### SCOUR ANALYSIS AND REPORTING FORM

Bridge Structure No. 50232140 Date 6/19/12 Initials Pat Region (A B C D) C  
 Site \_\_\_\_\_ Location 2.2 mi E of Renner corner on 2585  
 $Q_{100} =$  3990 by: drainage area ratio \_\_\_\_\_ flood freq. anal. \_\_\_\_\_ regional regression eq. X  
 Bridge discharge ( $Q_2$ ) = 3990 (should be  $Q_{100}$  unless there is a relief bridge, road overflow, or bridge overtopping)

Route 258 St Stream \_\_\_\_\_ MRM \_\_\_\_\_ Date 6/19/12 Initials RJT  
 Bridge Structure No. 50232-140 Location 2.2 mi E of Renner Corner on 258 St  
 GPS coordinates: N 43° 36' 44.8" W 96° 40' 13.3" taken from: USL abutment  centerline of  $\uparrow$  MRM end \_\_\_\_\_  
N 36° 3.4' W 96° 40' 13.3" Datum of coordinates: WGS84  NAD27 \_\_\_\_\_  
 Drainage area = 24.7 sq. mi. ~~24.7~~ *correct location*  
 The average bottom of the main channel was 17.4 ft below top of guardrail at a point 73 ft from left abutment.  
 Method used to determine flood flows: \_\_\_\_\_ Freq. Anal. \_\_\_\_\_ drainage area ratio  regional regression equations.

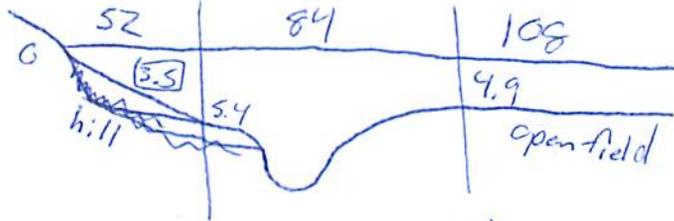
~~Re-do wrong Q values used~~

~~OK RT~~ OK RT
